SYDNEY NORTH PLANNING PANEL

Panel Reference	PPSSNH-140																											
DA Number	DA113/2020																											
LGA	Lane Cove																											
Proposed Development	Mixed-use development including a 143-bed residential care facility and commercial premises including a medical centre premises, and basement parking.																											
Street Address	4-18 Northwood Road & 274-274A Longueville Road, Lane Cove																											
Applicant/Owner	Applicant: City Plan (Contact: Elyse Kenny) Owner: Pathways Property Group Pty Ltd																											
Date of DA lodgement	28/08/2020																											
Number of Submissions	256																											
Recommendation	REFUSAL																											
Regional Development Criteria (Schedule 7 of the SEPP (State and Regional Development) 2011	Development that has a capital investment value of more than \$30 million (CIV \$40,837,440.00).																											
List of all relevant s4.15(1)(a) matters	• List all of the relevant environmental planning instruments: s4.15(1)(a)(i) - SEPP (Housing for Seniors or People with a disability) 2004 - SEPP 55 – Remediation of Land; - SEPP (In

Figure 21. Sections – public domain 1 (Source: DA311 Rev DA1, Morrison Design Partnership Architects).

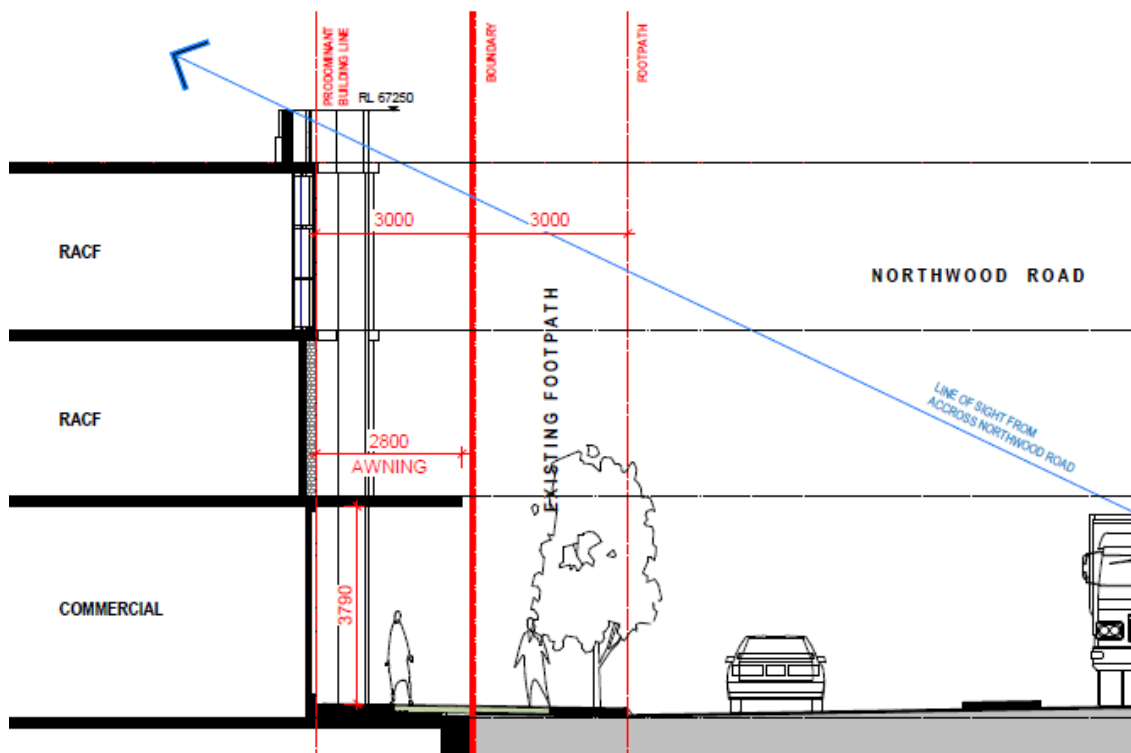
The proposal would not adhere to the *recessed third floor* requirement in that the proposed 3-storey form to the street alignment, as shown in the public domain section (**Figure 21**) and 3D pedestrian view (**Figures 22 & 23**) would create a walled effect at the pedestrian scale (**Figure 24**).

The 3-storey built form would not adhere to the desired future character for the neighbourhood expressed in the site-specific 2-storey to the street alignment and recessed upper level requirements under Clause 10. In this regard, the bulk and scale would establish an undesirable precedent for the centre. The proposed 3-storey form would not compromise the functional requirements of the aged care use. As stated previously, the proposal would not provide for an appropriate transition to adjacent low density residential uses to the south. For these reasons, the proposal does not satisfy objectives (1), (4), and (5).

Figure 25. Northern side boundary showing native Turpentine trees to be removed (Source: Landscape Plan LP01 prepared by Svalbe & Co)

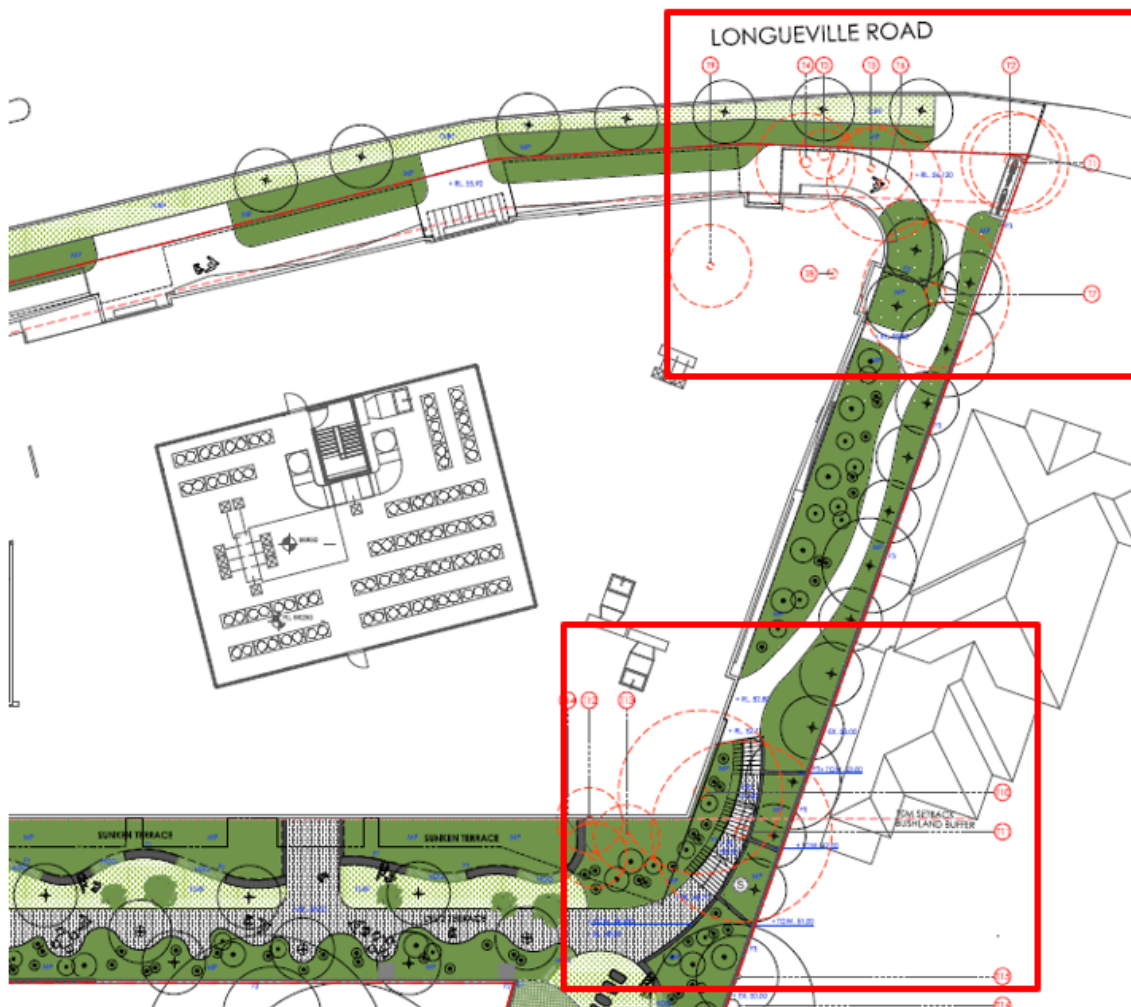
The removal of turpentine trees T1, T2, T5, T6, T10 and T11 is not supported (**Figures 25 & 26**). T10 and T11 along provide 300m² of canopy coverage (**Figure 27**). It is recommended that the proposal is amended to retain these native trees.

Figure 28. Non-compliant rear setback of 2.75m (southern side) and 3m (northern side) for the curtilage to the south-eastern section of the development.

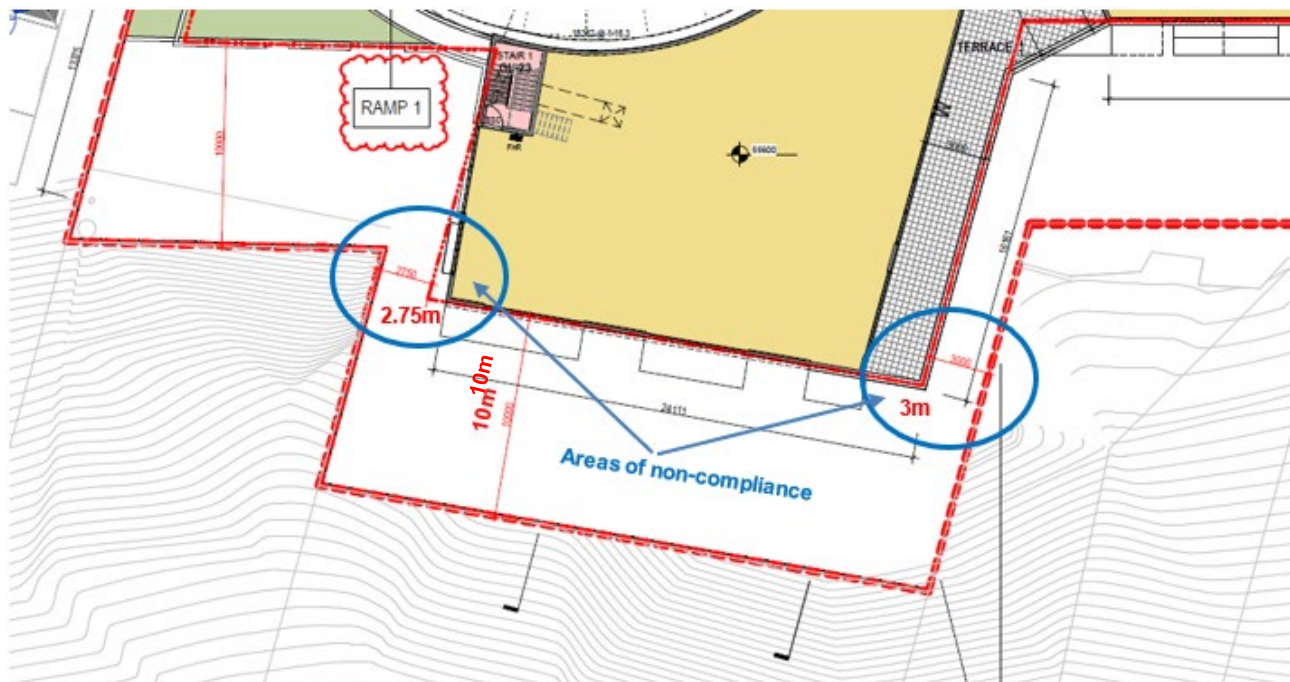
The curtilage to the proposed south-eastern section of the proposed building at the rear comprised of a 2.75m setback on the southern side and 3m setback on the northern side would not comply with the 10m buffer zone requirement, which seeks to ensure that the adjoining bushland is maintained and protected (Figure 28).

Figure 29. Indicative 10m buffer (Part H, Lane Cove DCP 2010)

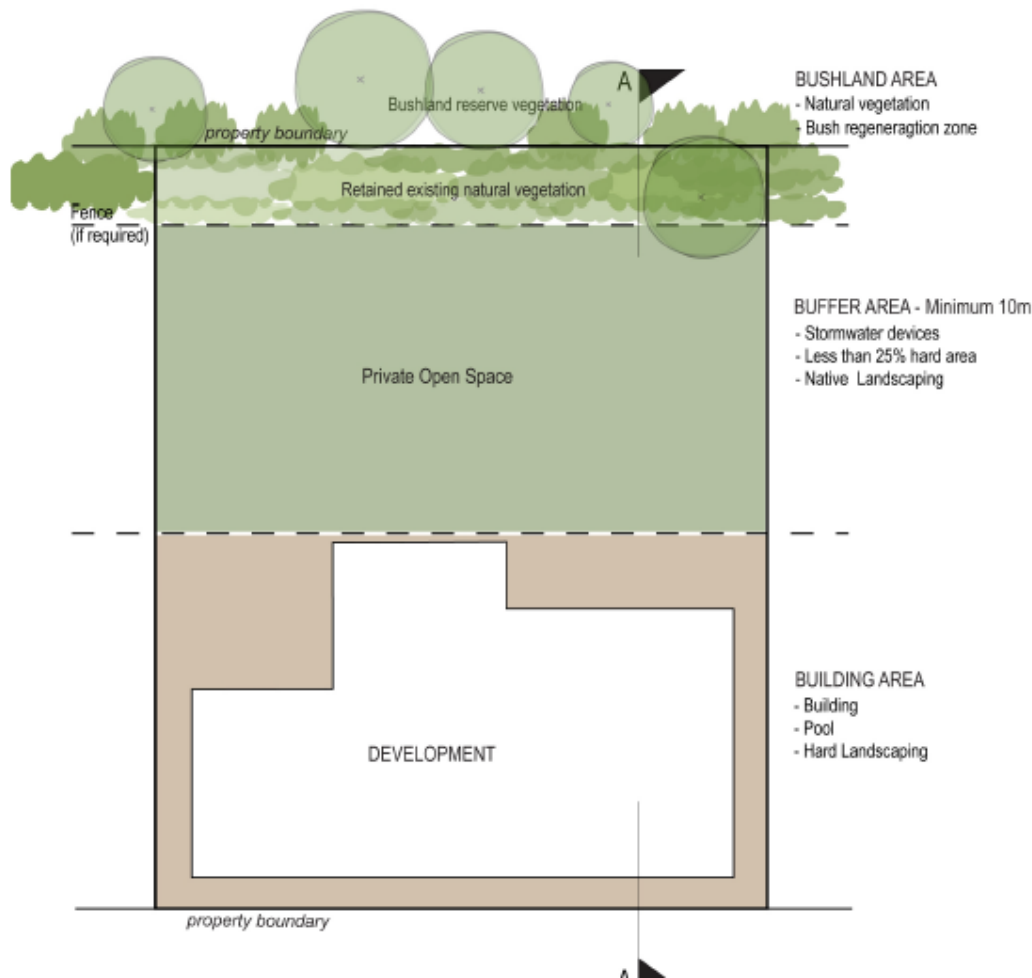
Provision (f) states that a minimum depth of 10m should be provided to adjoining bushland and should not impact upon any trees or vegetation (**Figure 29**). Except for the southern boundary, the curtilage to the south-eastern section of the development proposes a 2.75m and 3m setback to adjacent E2 zoned land. This is contrary to provision (f).
